File Number: 9-F-25-IH

Location: 3547 Oswald St. **Parcel ID:** 69 N E 00401
Zoning: I-MU (Industrial Mixed-Use)
Description: Revisions to multi-family building (8-G-23-IH)

Revisions to 8-G-23-IH, new multi-family building that is part of a multi-phase 8-acre mixed-use development. See end of file for detailed list of changes by elevation.

DESIGN REVIEW REQUEST

1 SITE PLAN PH-1.2
A001 1/16" = 1'-0"

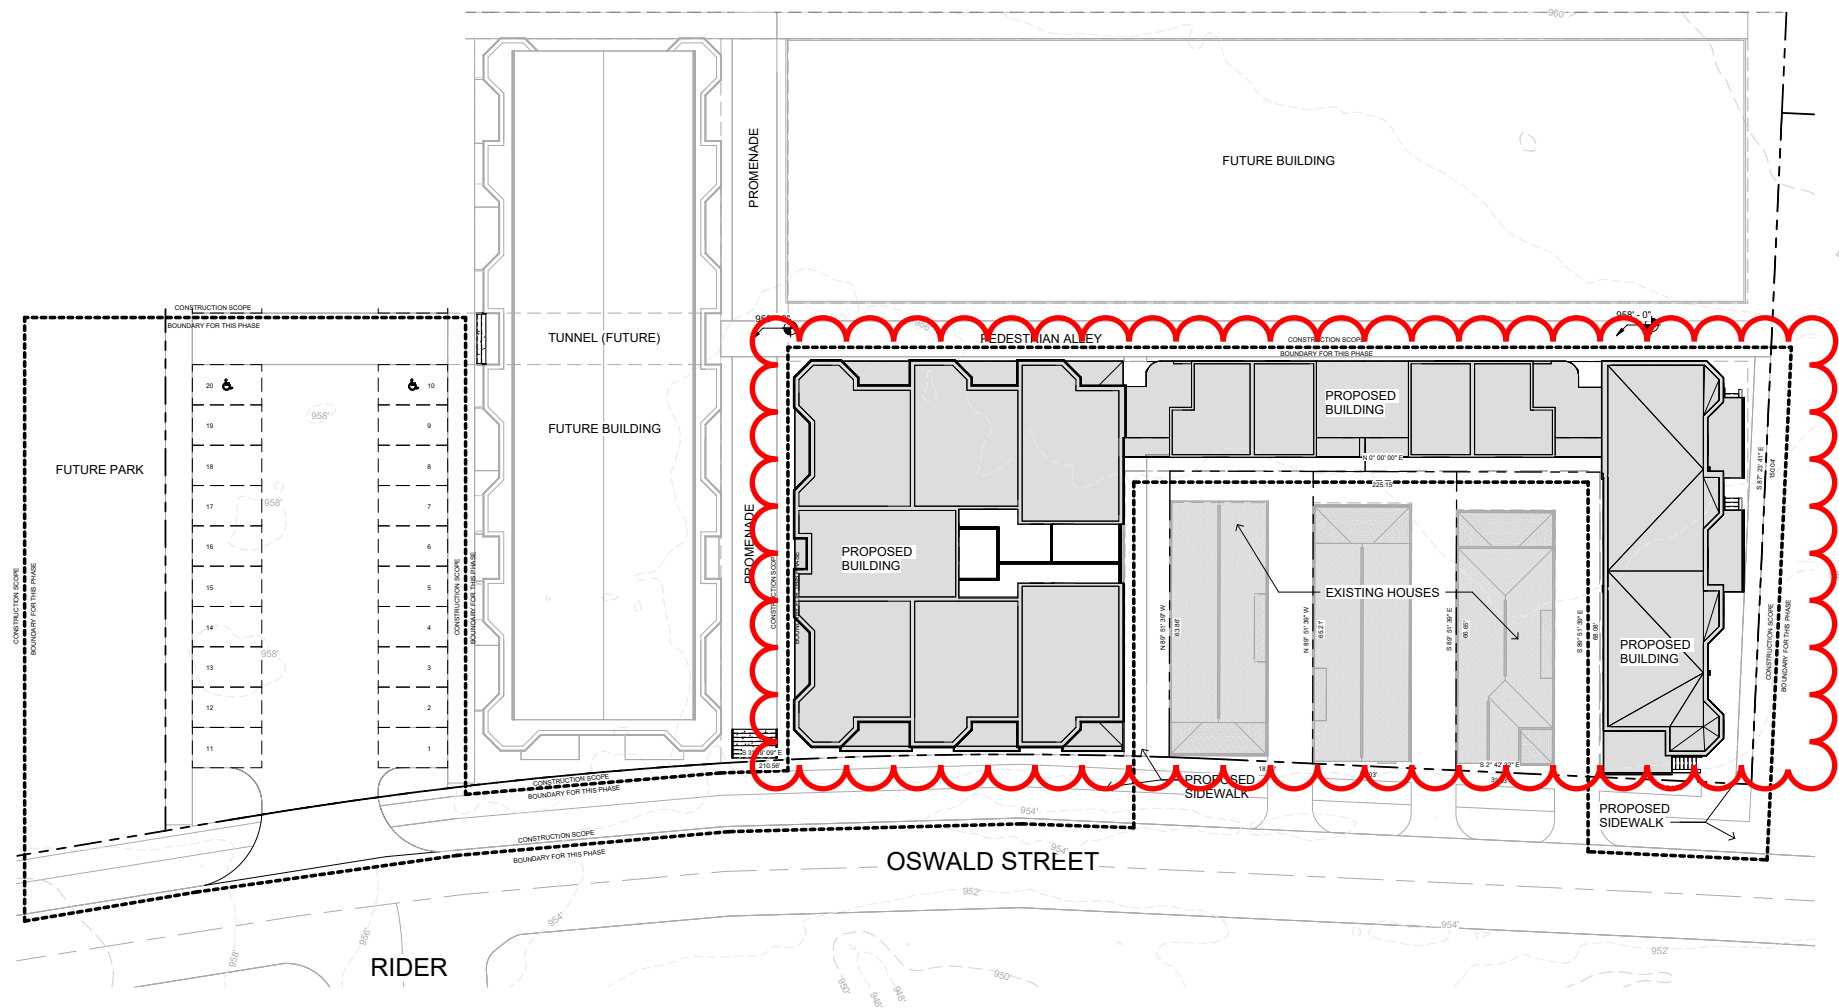
2. The site plan has been adjusted to reflect the building massing revisions, which resulted in reduced setbacks that are not dimensioned on the plans. The setbacks scale to 1 to 3 feet from the front property line, or 3 to 5 feet from the back of the proposed public sidewalk. As a result of the reduced setback and increased foundation height (6' tall), the walkways and porch stairs for the three left (south) Oswald Street facing units have been removed. The

front setback should be increased, and the foundation height reduced as necessary or to the preference of the Board, to allow for the stairs and walkways from the porches to the public street to be reintroduced and shade trees in the front yard as recommended by the design guidelines, as well as other plantings, to lessen the impact of the foundation height and overall massing in relation to the nearby structures, public street, and proposed public sidewalk.

3. The parking lot setback has been reduced from 15'-4" to approximately 5', and the driveway location is now offset with the intersection of Rider Avenue. The applicant is encouraged to discuss the driveway location with City Engineering before moving forward with detailed construction plans and design development of the adjacent future building. The driveway and parking lot drive aisle scale to a width of 30', which is greater than the minimum 20' driveway and 26' drive aisle widths required. The driveway and parking lot dimensions should be reduced to the minimum necessary for adequate functionality of the average user to ensure safety for pedestrians and motorists along Oswald Street, a narrow residential road.

4. The landscaping on the previous site plan is now absent. Landscaping should be introduced along the parking lot and all elevations, including shade trees along Oswald Street. The final site plan should meet the landscaping standards of Article 12 and all other applicable zoning and City Engineering standards, with final selection and design of landscaping to be approved by staff.

- 2) City Engineering approval of the design of the parking area, its driveway access, and proposed sidewalks, with a reduction in drive aisle and driveway width to be approved by staff;

- 3) the front setbacks be increased and, if necessary, the foundation height reduced, to allow for the reintroduction of stairs and walkways from the porches to Oswald Street, with final measurements and drawings to be approved by staff;

- 4) the final site plan to incorporate landscaping along the parking area and all elevations, including shade trees along Oswald Street, with final selection and placement to meet any applicable standards, including Article 12, and be sent to staff for approval;

Site plan 8-G-23-IH

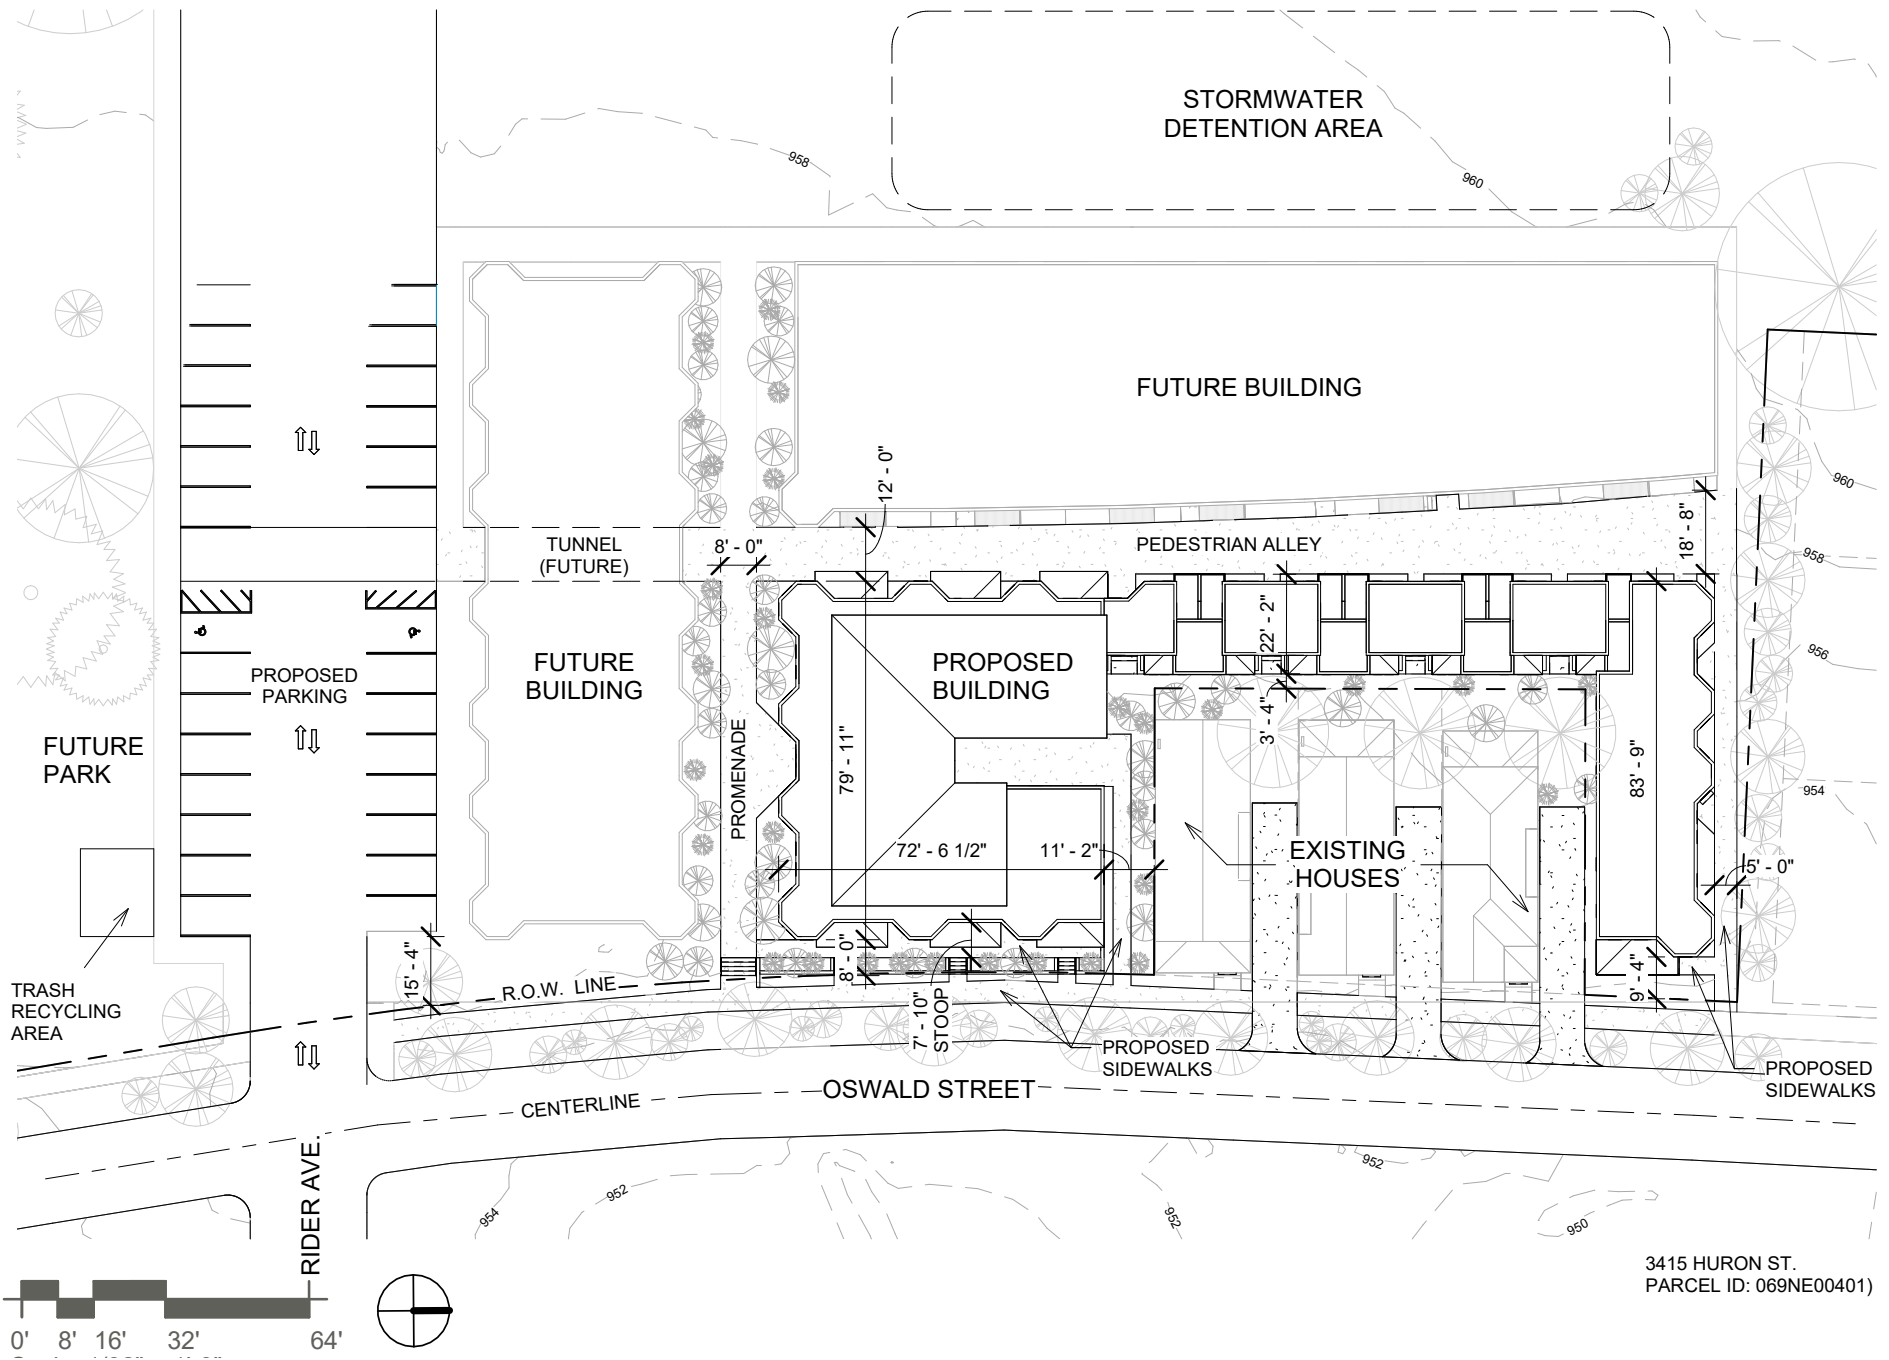
Site plan: The site plan features the similar parking and building placement that was previously approved, but it has been modified to depict proposed changes to building forms. Setbacks are not depicted on the revised site plan but appear to have been reduced to account for changes to the building form. Along the Oswald Street frontage, the buildings are depicted up to the front property line with minimal setback, reduced from approximately 8'. Along the north lot line, massing of the building has a slightly larger setback, but porches have been added to the north elevation that extend within 5' of the lot line. The proposed public sidewalk has an approximate 2' separation from the front lot line. Landscaping is not depicted, as it was previously. Removal of walkways from front porches to Oswald Street. The parking lot access has been offset from Rider Avenue, and the front parking lot setback has been reduced.

Elevations 8-G-23-IH

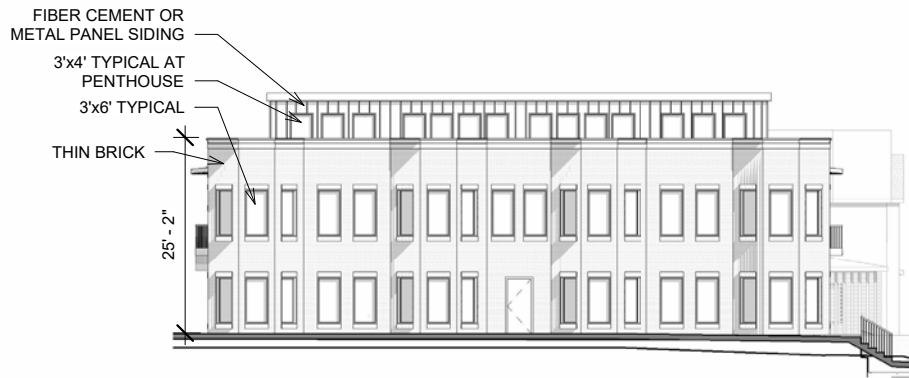
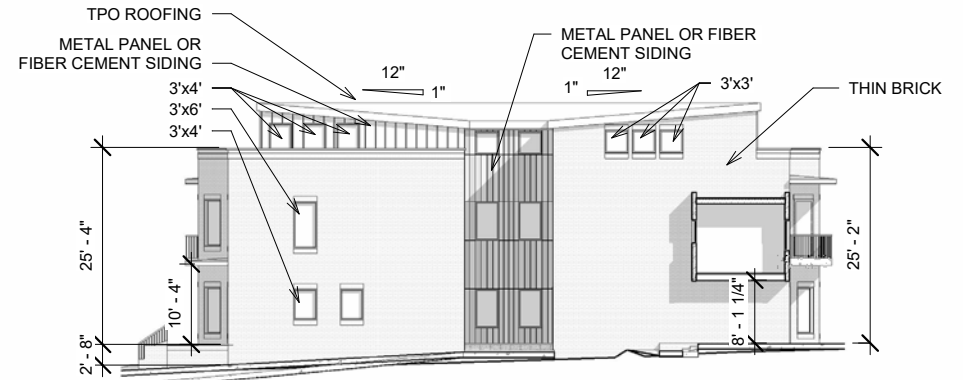
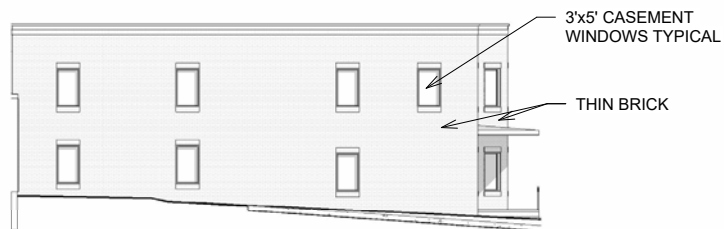
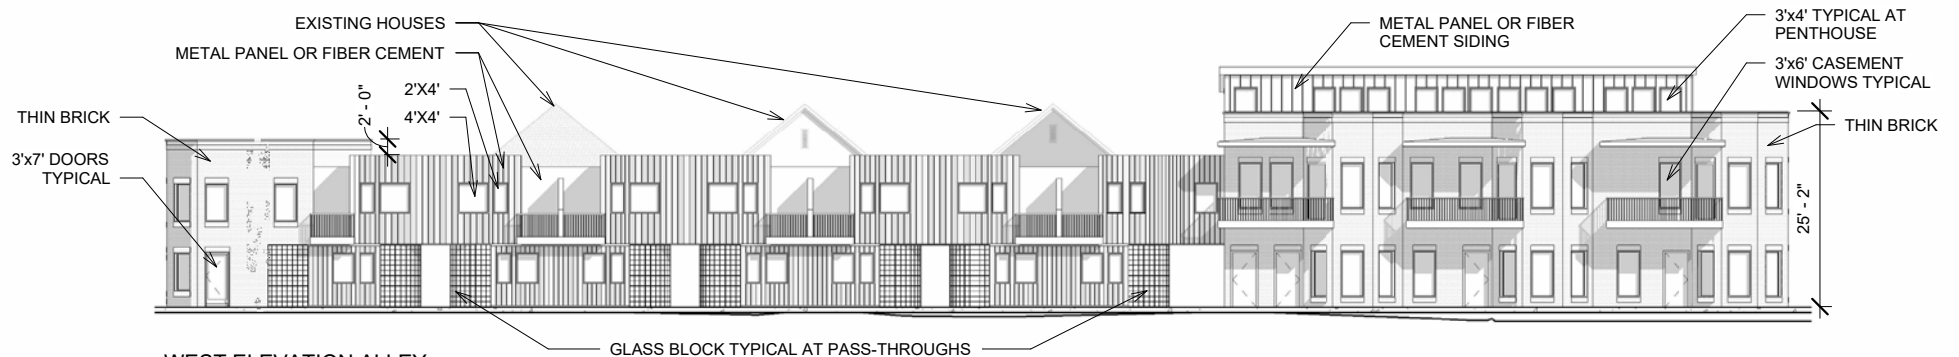
Left (brick) massing: Increase foundation height from 3'-2" to 6'. Replace casement windows with fixed windows. Removal of brick soldier course from windows and doors, and removal of brick sills from windows on the left bay window massings. Removal of the third-story, paneled penthouse massing on the left bay window massings. Modifications to the two-story bay window form to feature a straight left side and an angled right side to the projection, as opposed to two angled sides, widening the central bay to feature two windows on each story instead of one and removing the windows on the left side. Second-story balconies will be recessed to be flush with the edge of the bay window projection, instead of projecting from the edge of the bay window. The street entrances to each unit have been removed and replaced with first-story patios enclosed with a railing, and the brick coursing from the entrances is now only present as a water-table on the patios. The patio and balcony roofs have been modified to adjust to the shape of the new bay window massings.

Right (brick) massing: Increase foundation height from 1'-4" to 6'. The right bay window massings have been modified in the manner previously described, removing the windows on the left side and featuring paired fixed windows in the central bay. The first-story entrance is now an individual instead of shared entrance and has been widened to have the steps accessed from the right side and hidden by a brick knee wall with two rows of coursing, and the porch is now recessed instead of projecting, featuring a handrailing. The height of the parapet has been increased to rise above that on the left bay window massing, and the brick coping has been removed.

Center (vertical siding) massing: Modifications to massing pattern of central bays. Second-story smooth-finished massings have been reduced in height and width and now have a rectangular form (previously T-shape). There will be three massings instead of four, and they have been

recessed to allow for a patio flush with the vertically-paneled massings. The vertically-paneled massings have been combined into one long massing on the first story, with two sections of two-story projections that rise above the smooth-finished massings. The window patterns have been revised to feature alternating bays of small fixed windows and taller, paired casement and fixed windows. There will be two first-story openings for pedestrian openings, instead of four, and the width of the openings has been reduced. The curved glass blocks flanking the openings have been removed.

West elevation (alley-facing): Removal of brick soldier course from windows and doors, and removal of brick sills from windows on the right bay window massings. Most casement windows have been replaced with fixed windows, which are wider and shorter than previously proposed. Removal of the third-story, paneled penthouse massing from right bay window massings. Same modifications to the form and second-story balconies on the right bay window massings as described for east (Oswald Street) elevation. Removal of leftmost balcony. Balcony design revised to feature a window to the left of a door. Revisions to door and window placement on first story, creating off-set door pattern. Addition of roof on first-story of leftmost bay and removal of one door. Connection to central massings is now a brick-clad hyphen above the pedestrian opening.

North (facing towards Colonial Avenue) elevation: Removal of brick soldier course from windows and doors, and replacement of most casement windows with fixed windows. Modifications to two central bay window massings, similar to those described for the east (Oswald Street) elevation, with the straight plane on the right side of the bay and paired fixed and transom windows in the central plane. Revision to massing placement, window pattern, and door placement. The width of the leftmost flat massing has been reduced, and all windows have been removed with a downspout in their place. Two one-story porches with flat roofs and their

South (promenade-facing) elevation: Removal of third-story paneled penthouse massing. Removal of brick soldier course and sills from all windows and doors, and replacement of most casement windows with fixed windows. Modifications to two central bay window massings, similar to those described for the east (Oswald Street) elevation, with the straight plane on the right side of the bay on one massing and the left side of the bay on the other. The widened central bays feature one window, and a window on the right plane of the third bay window massing has been replaced with a full-lite glass entry with a side-lite. Installation of flat roof above the first story in the recesses between the bay window massings.
